Subject: Brunswick Steam Electric Plant, Unit Nos. 1 and 2
Renewed Facility Operating License Nos. DPR-71 and DPR-62
Docket Nos. 50-325 and 50-324
Response to Request for Additional Information Regarding Third 10-Year
Inservice Inspection Interval Request for Relief RR-46 (NRC TAC
Nos. ME1249 and ME1250)

Response to Request for Additional Information Regarding Third 10-Year Inservice Inspection Interval Request for Relief RR-46

10 CFR 50.55a Request Number RR-46

Attachment 3
(Supporting the Response to NRC Question 3)

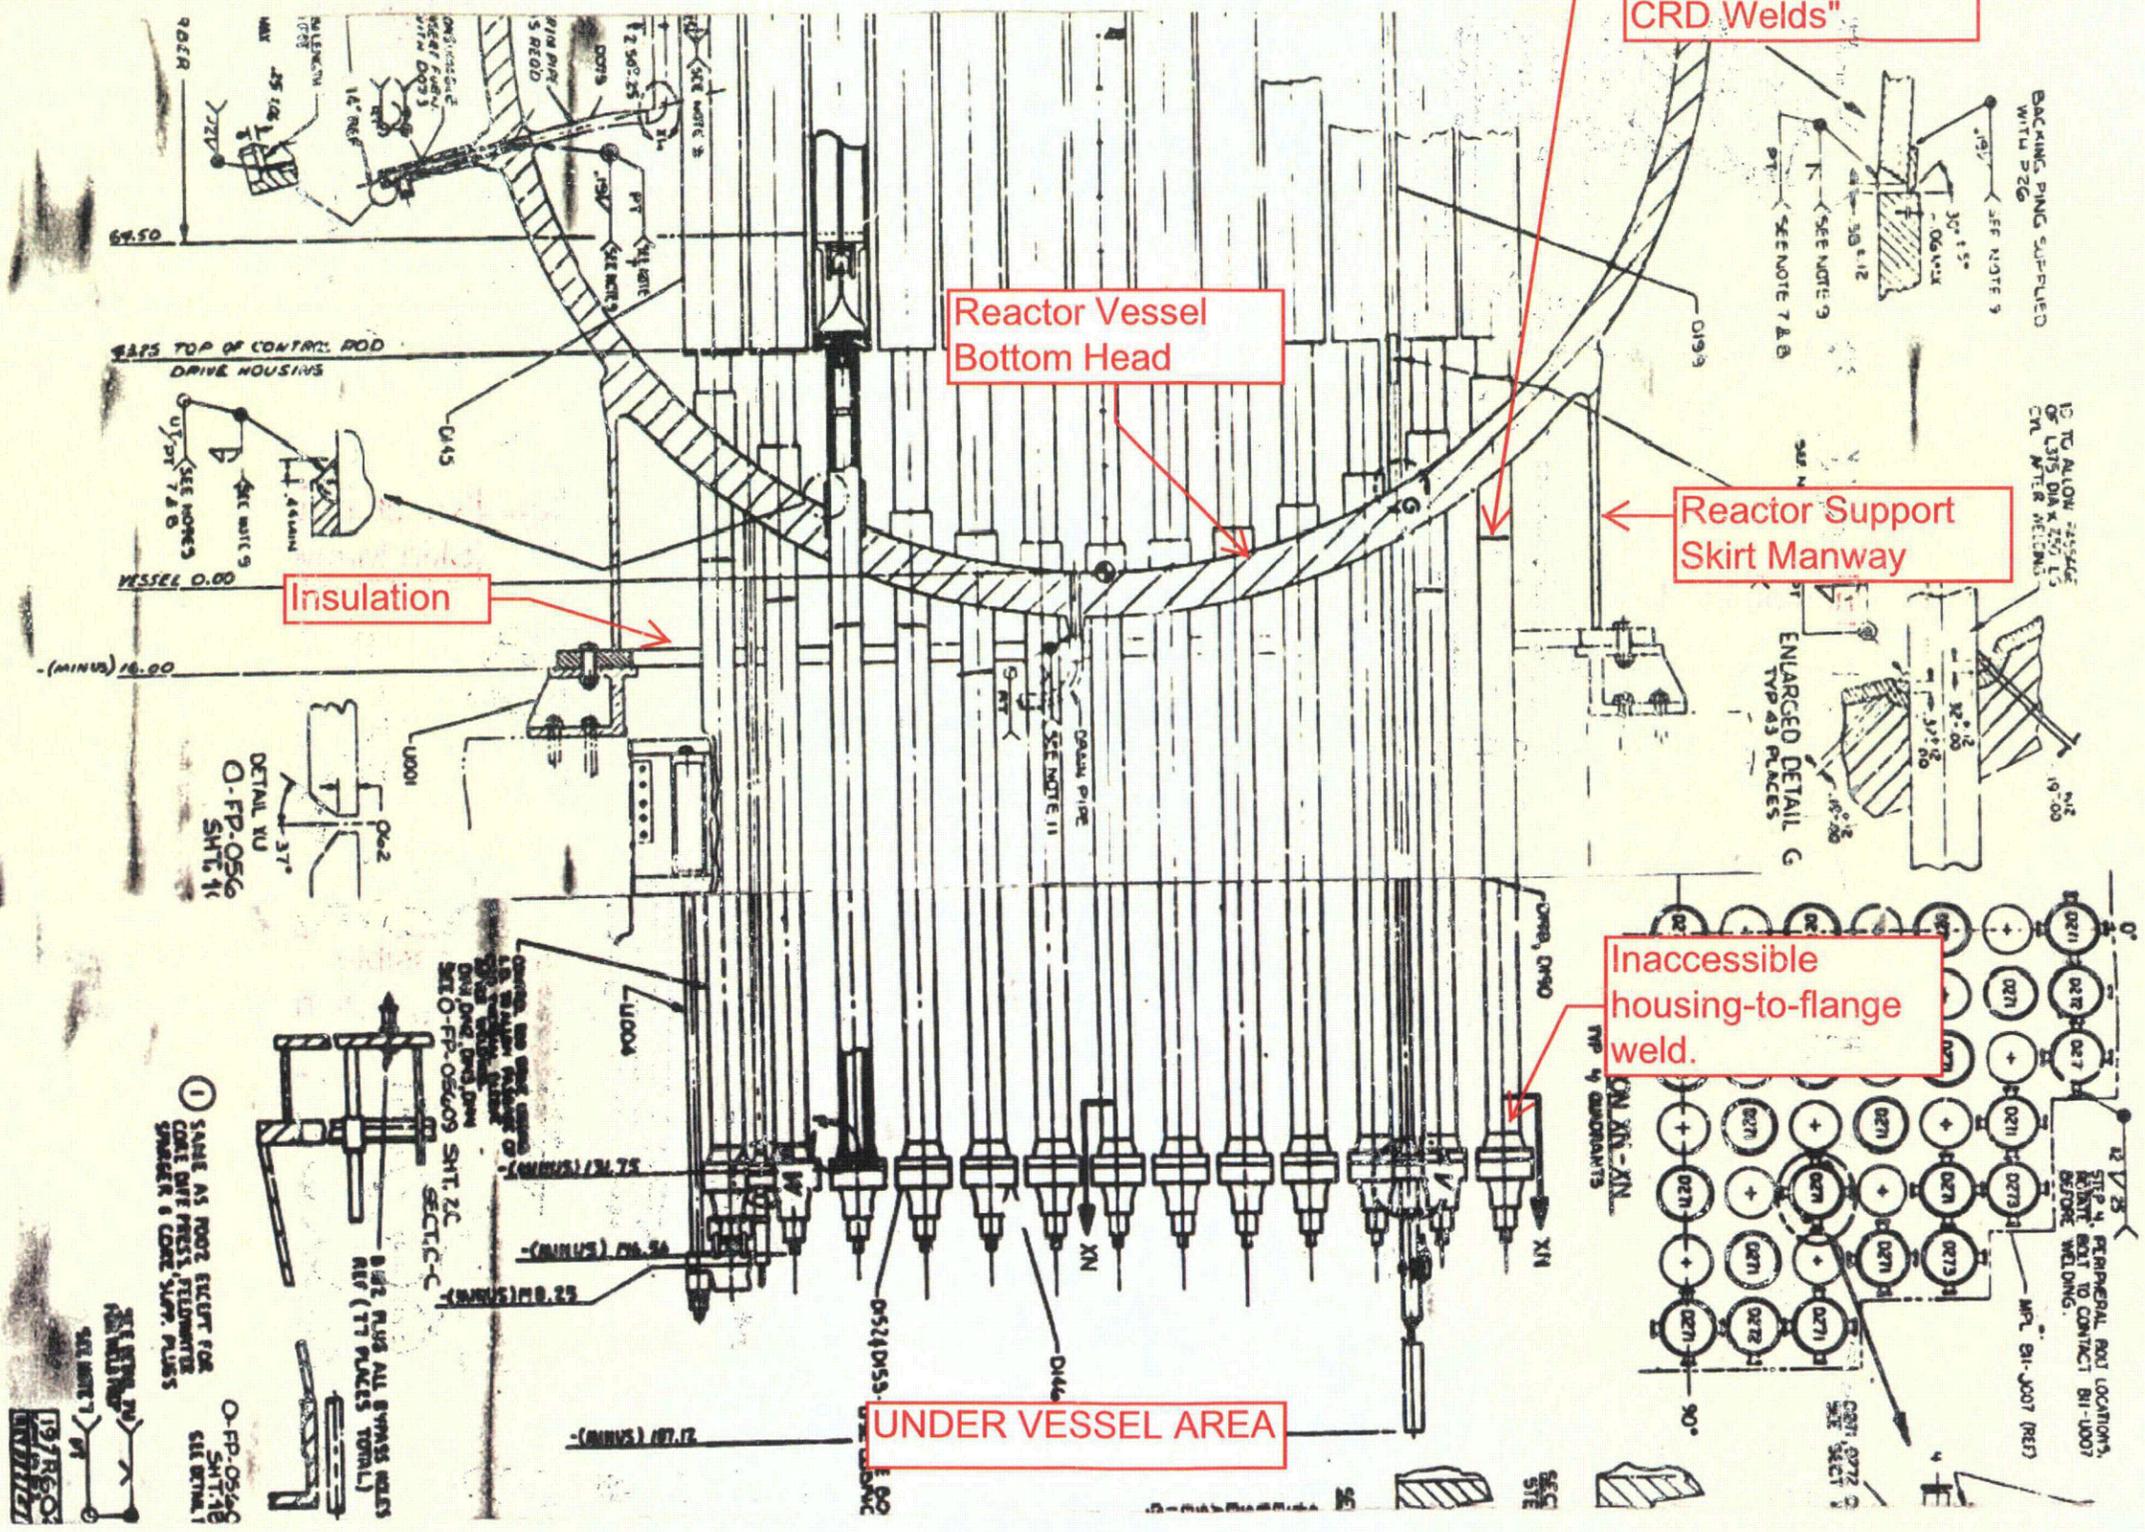
On Attachment 1 to Relief Request No. RR-46, clearly identify both the housing-to-flange weld and the housing tube-to-tube weld.

A portion of a different drawing is provided in Attachment 3 and depicts the same CRD feature-of-interest as shown in the previously submitted Attachment 1. The drawing in Attachment 3 has been annotated to identify both the housing tube-to-tube weld and the housing-to-flange weld.

Accessible housing tube-to-tube weld on outer periphery. See Photo "Upper CRD Welds"

Inaccessible housing-to-flange weld.

Attachment 4
(Supporting the Response to NRC Question 4)

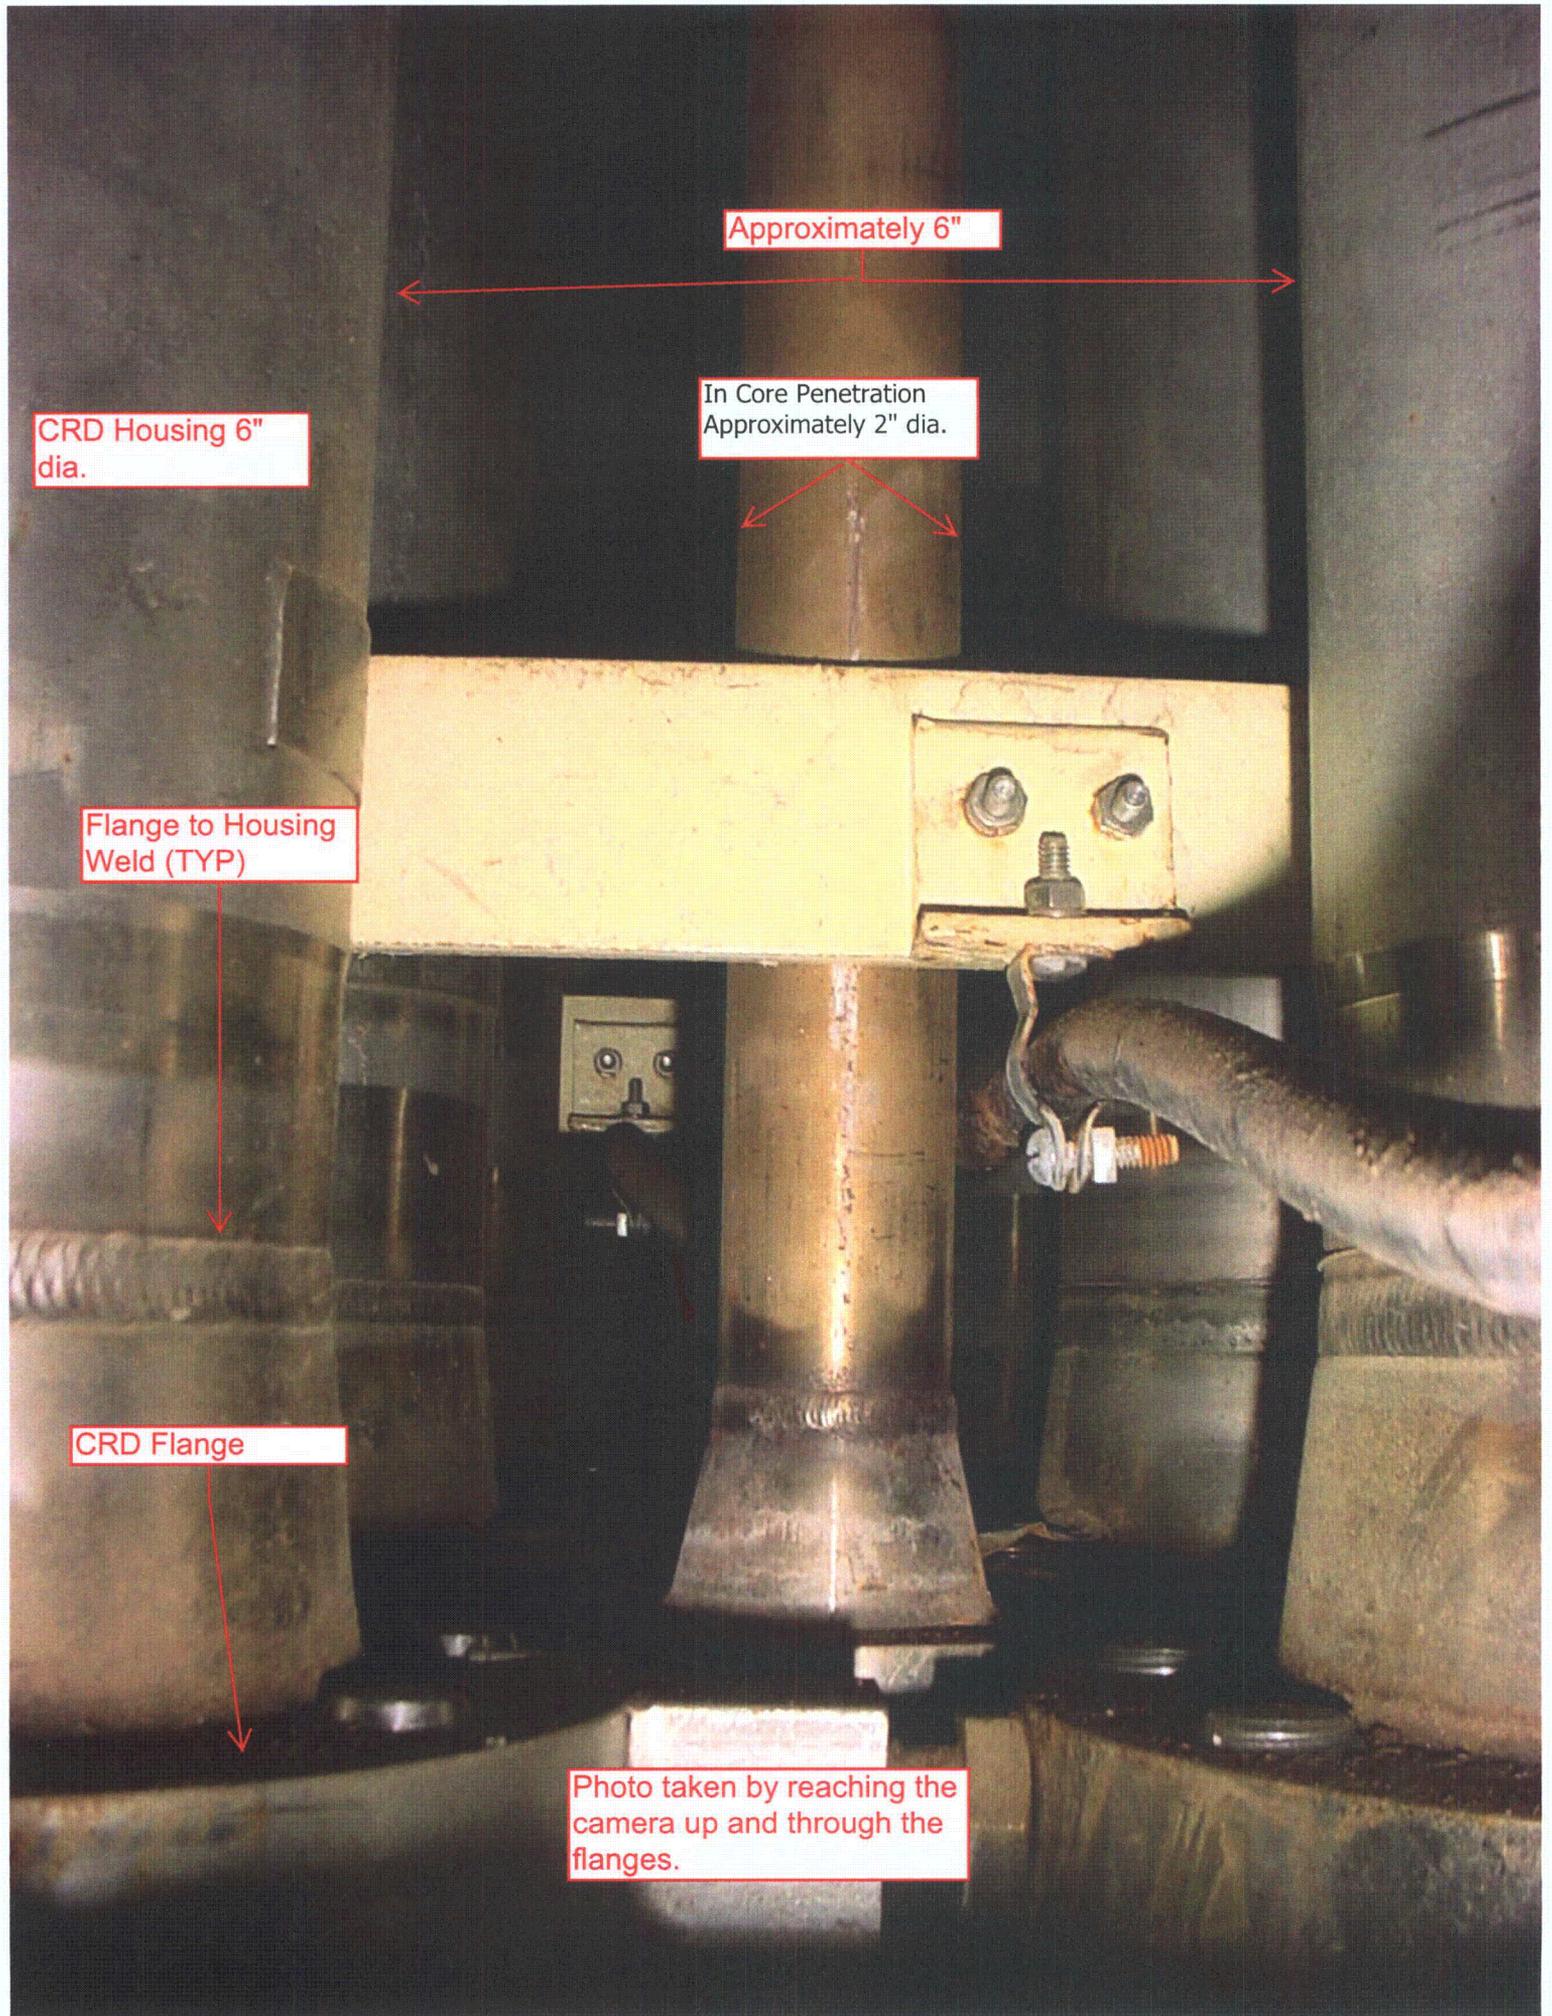
For Figures 1 and 2 in Attachment 4, clearly identify one housing-to-flange weld and one housing tube-to-tube weld on each photo. Provide enlarged photos, if necessary.

Is it possible to examine any portion of the lower housing-to-flange weld on any peripheral CRD housing? If not please provide specific details as to why this is not possible.

The welds are not visible in the Figure 1 contained in CP&L's letter dated May 8, 2009. Figure 1 shows the general under-vessel area with various instrumentation cabling. The CRD flanges are located in the shoot out steel above this cabling. Figure 2 in CP&L's letter dated May 8, 2009, depicts the CRD flanges looking up from under vessel. It was provided to show the obstructions and interferences that are limiting our access. Photographs are provided in Attachment 4 of this letter. These photos are annotated to indicate applicable features of interest.

As can be seen from the photograph provided in response to Question 4 above, a partial examination is not possible due to the limited access and obstructions.

Flange to Housing
Weld (TYP)

Upper CRD welds
at the manway. RV
can be seen in the
background.
Insulation support
can be seen below.
